Bid Addendum No. 1 for:

MASON TRANSIT AUTHORITY – BELFAIR PARK AND RIDE PROJECT

From: Patrick Holm, PE

DRAINAGE DETAILS

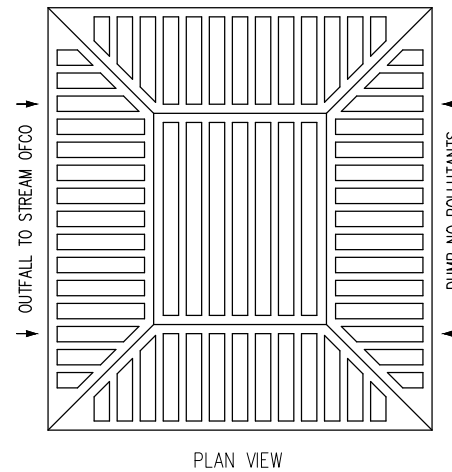
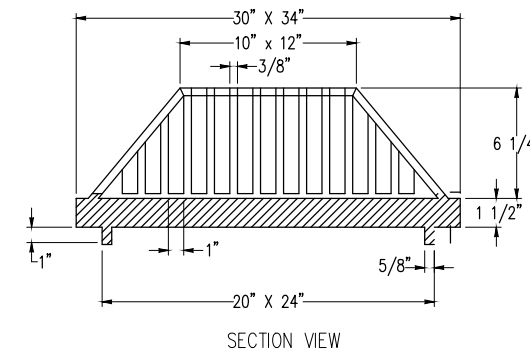
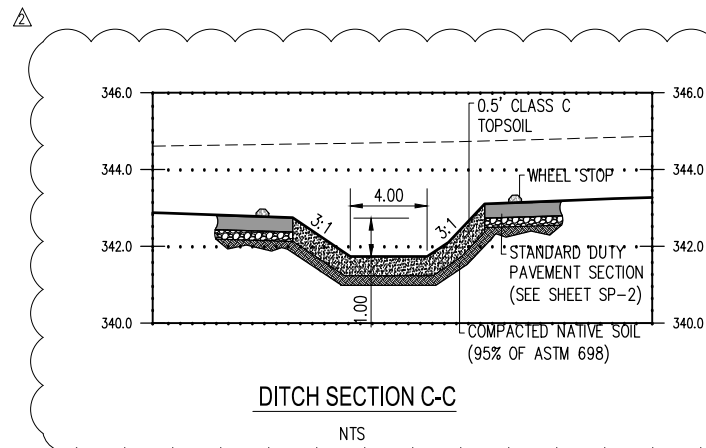
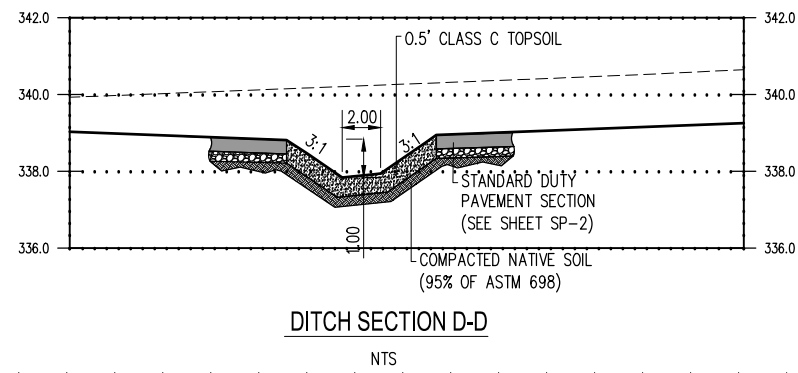
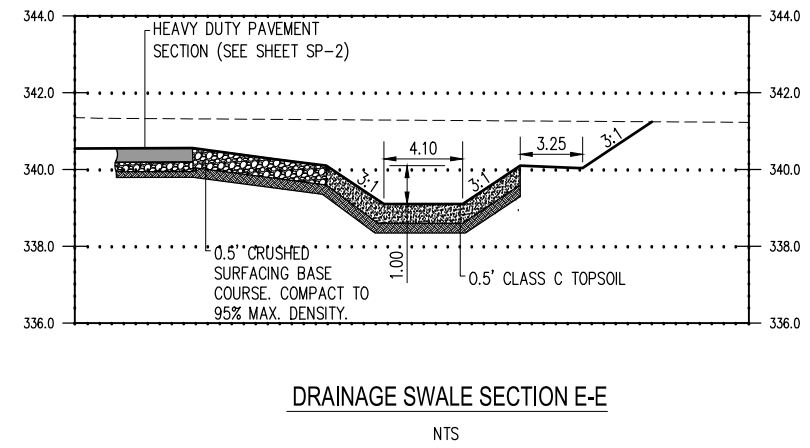
- Sheet SD-3: Replace with attachment SD-3 to include updated cross section details
- Sheet WA-1: Replace with attachment WA-1 to include updated water plans

WATER DETAILS

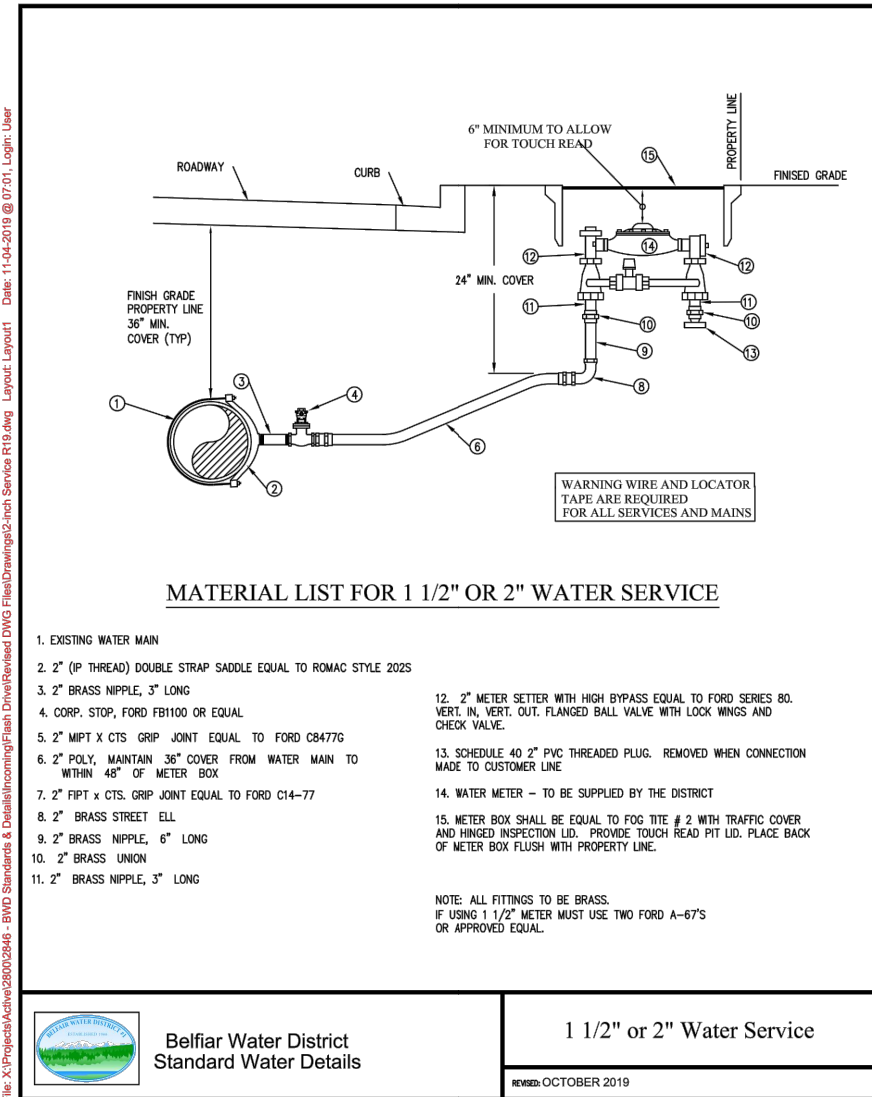
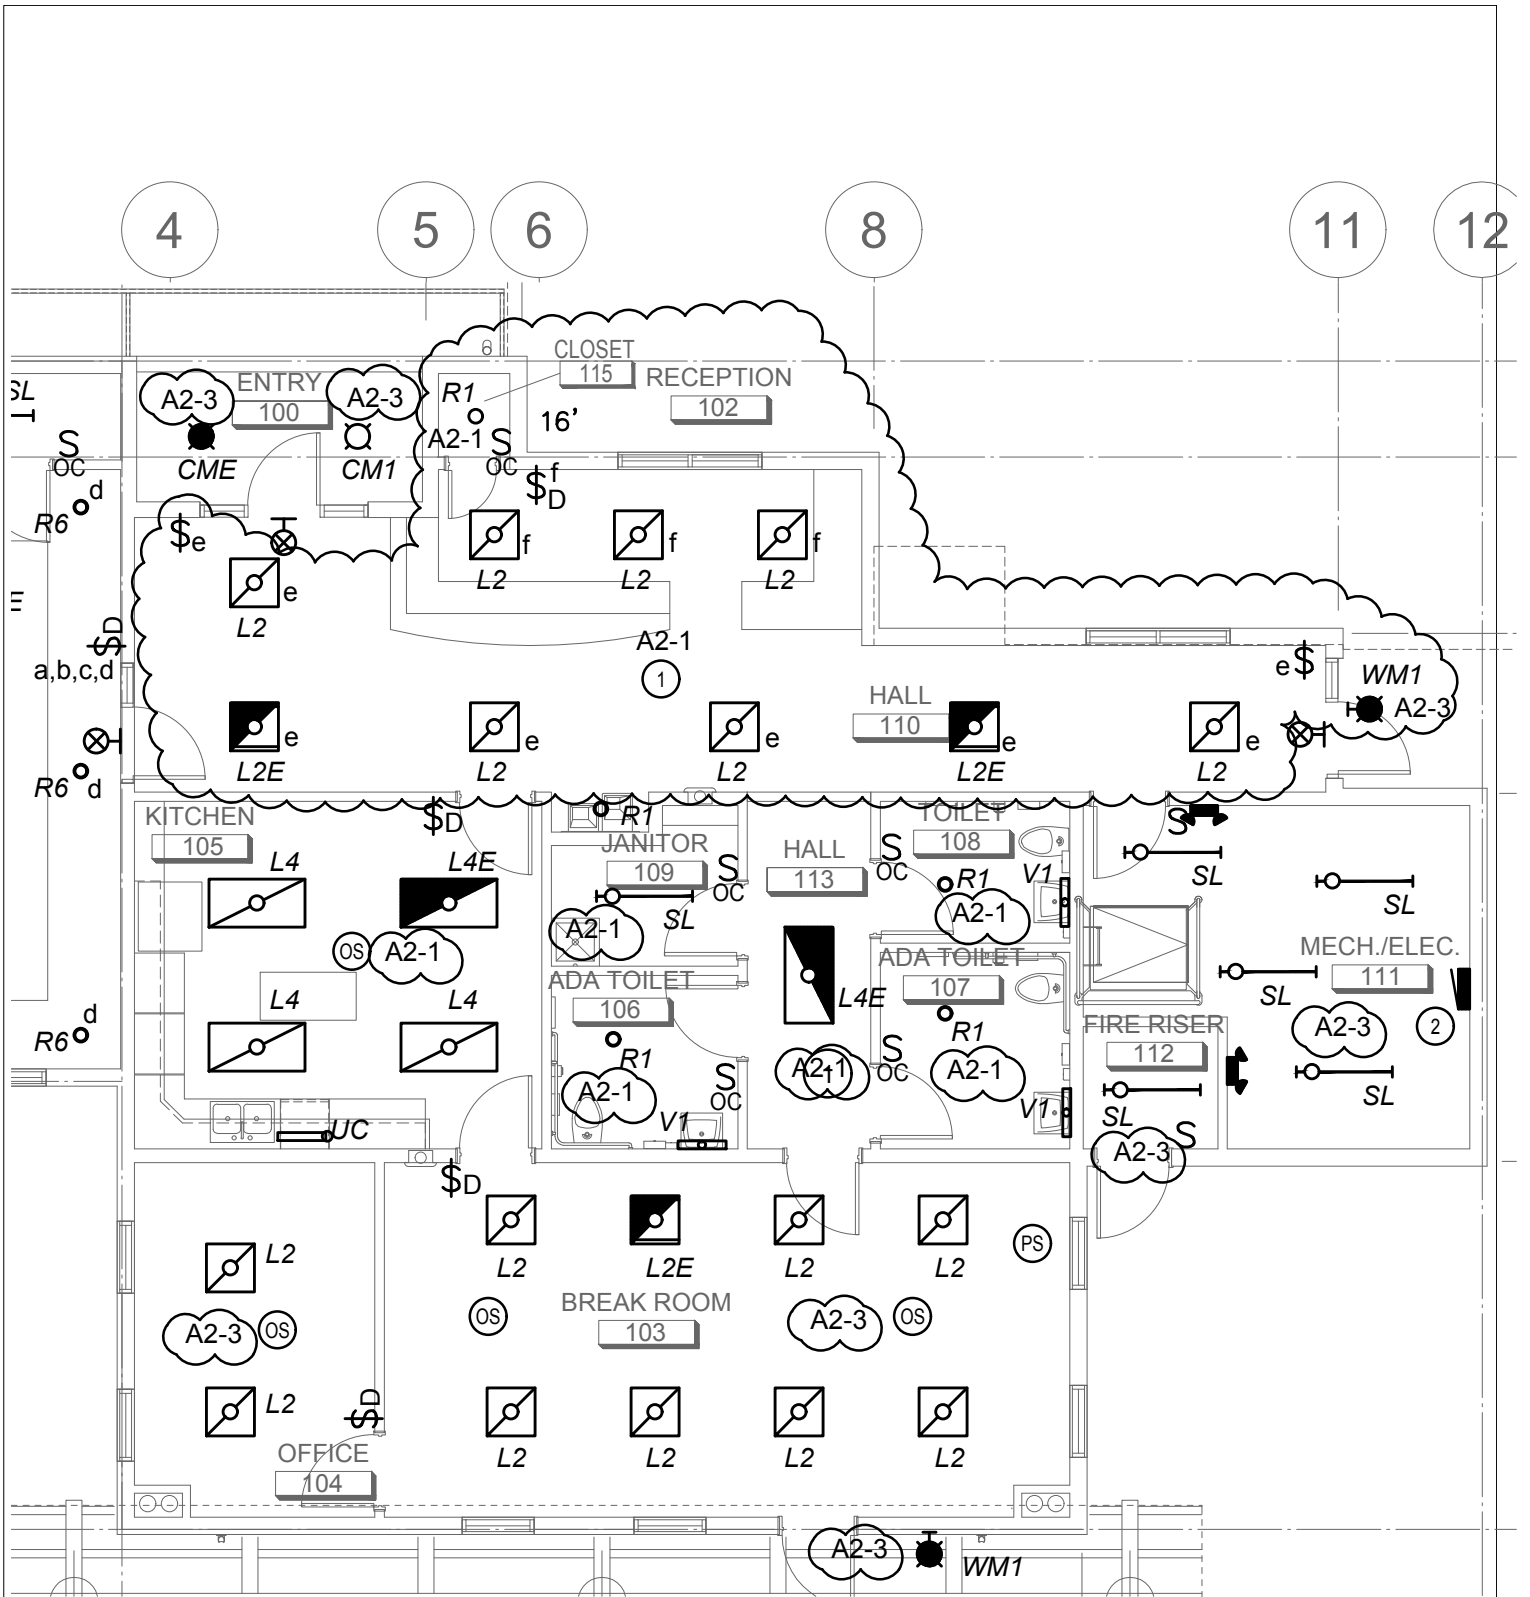
- Sheet WA-3: Replace with attachment WA-3 to include RPBA (reduced pressure backflow assembly) detail
- Sheet IL-1: Replace with attachment IL-1 to include parking lot light specifications

**PARTIAL LIGHTING PLAN
 ADDENDA NO. 1**

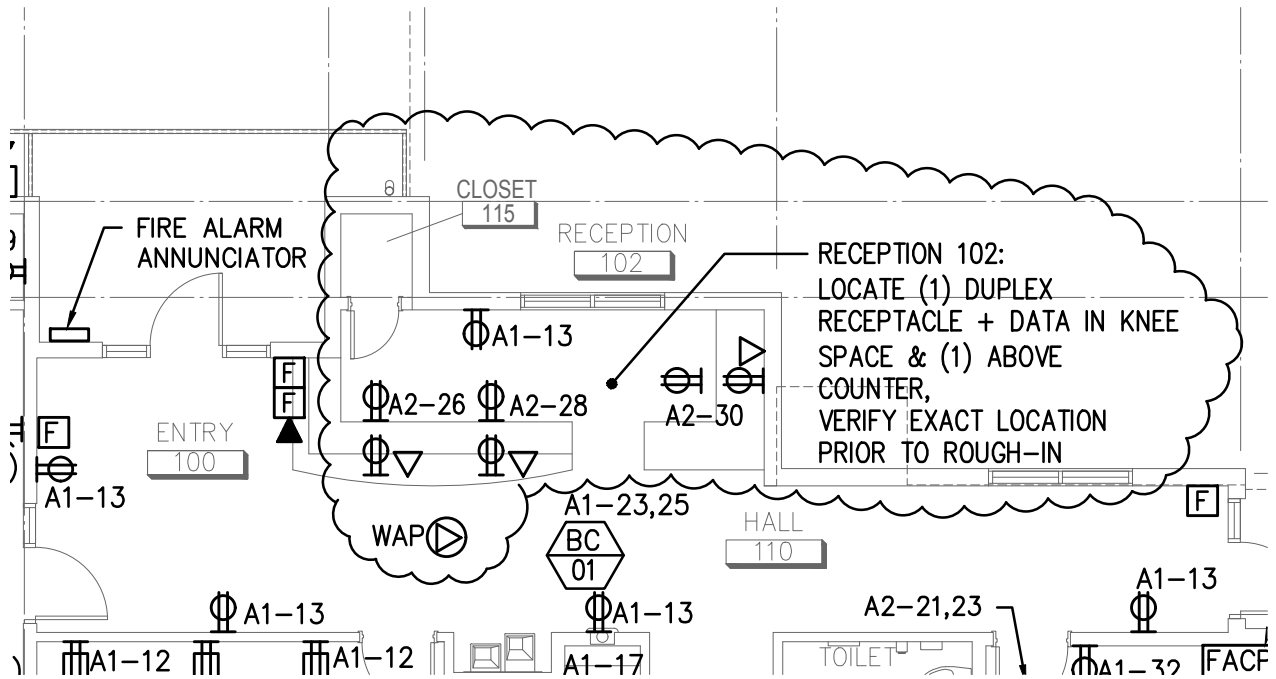
- Sheet E2.1, Hall 110: **REVISE** per attachment ESK-1 to include lighting and control for Reception 102 and Closet 115 [work includes but is not limited to addition of (1) type L2, (1) type R1, separate controls for Reception 102 from Hall 110 and control for Closet 115].
